**HISTORIC LANDMARK COMMISSION**  
**APPLICATION FOR A CERTIFICATE OF APPROPRIATENESS**  
**OCTOBER 5, 2022**  
**HR-2022-137410**  
**MARY LOWRY HOUSE**  
**4001 AVENUE C**

## **PROPOSAL**

Demolish a non-original garage and construct a garage apartment in its place.

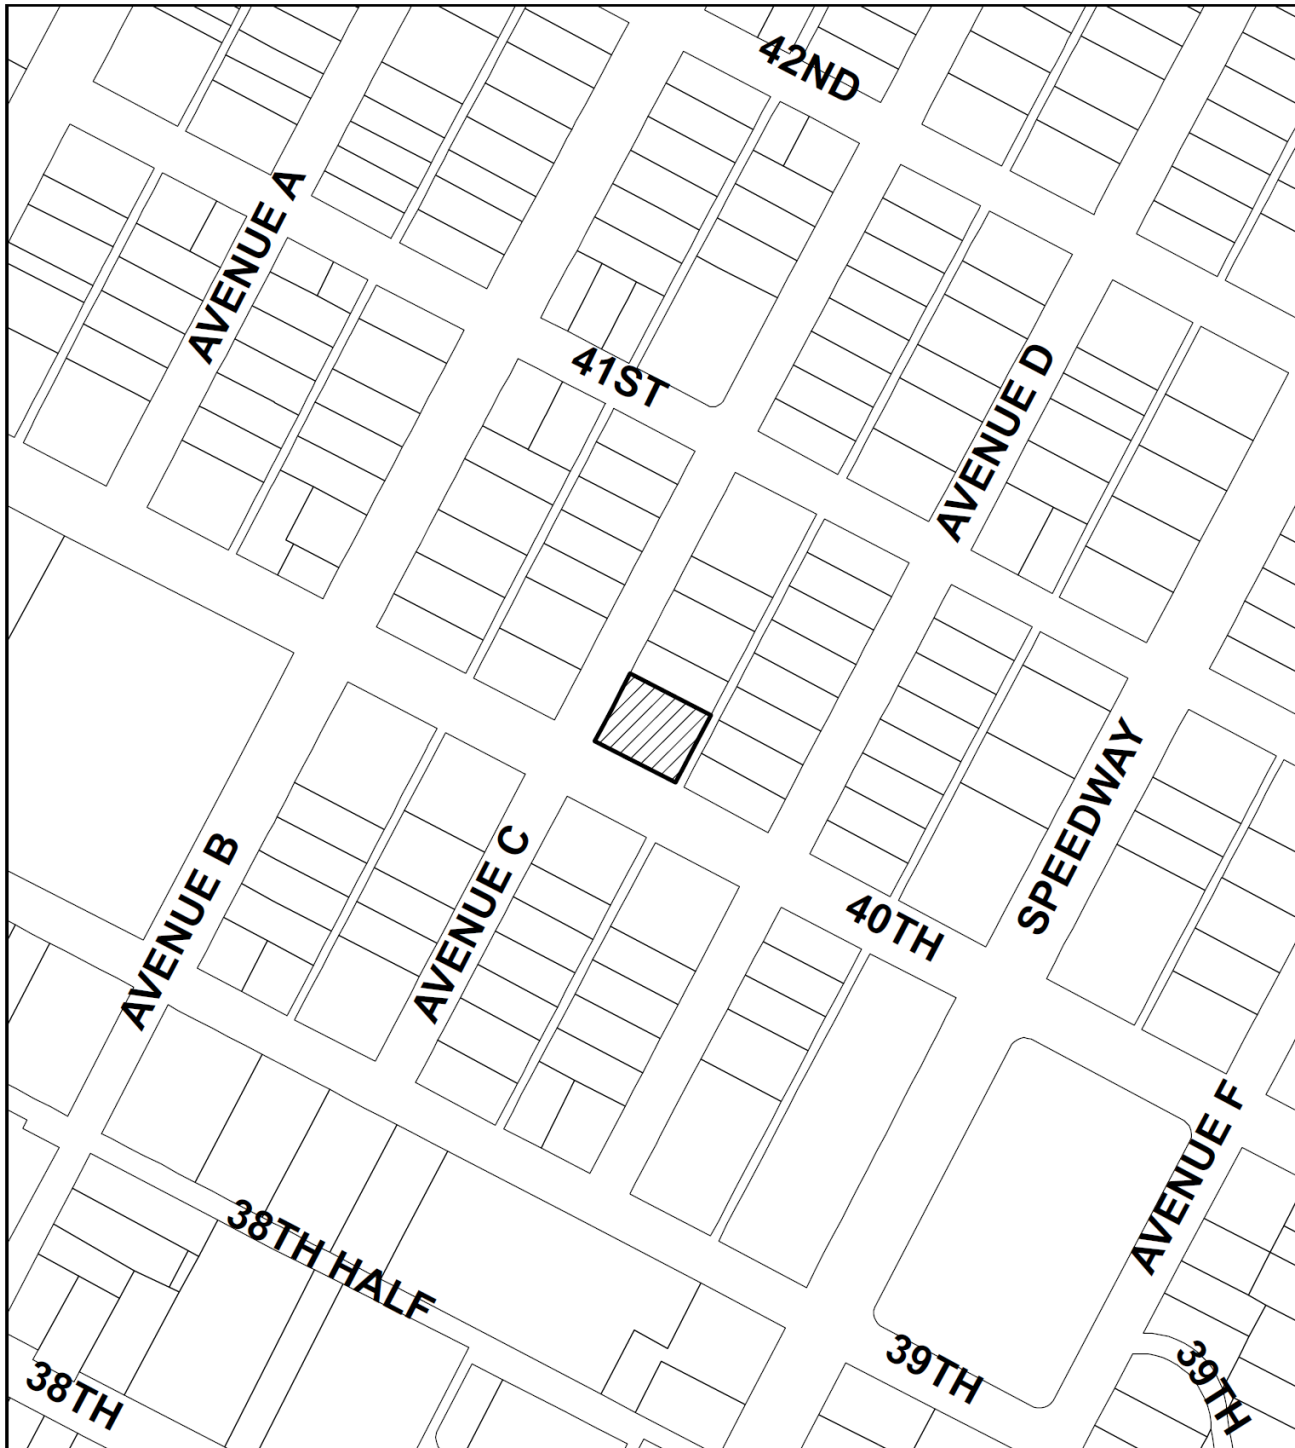
Use a more conventional window pattern, such as the south elevation. Provide materials and dimensions on drawings.
